# ADA Curb Ramp New Construction Inspection Form (Perpendicular)

NW Main

23885.56

NW Lenox

## PERPENDICULAR RAMP (PR)

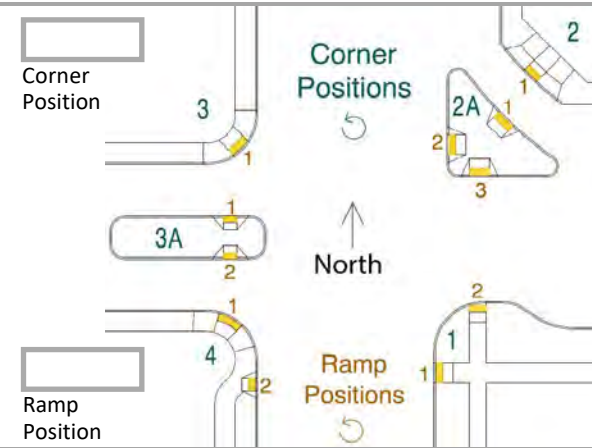
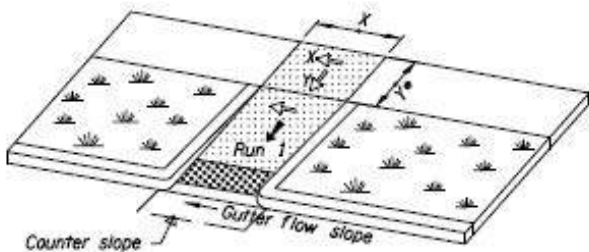
DWS IITD Fails RR 1
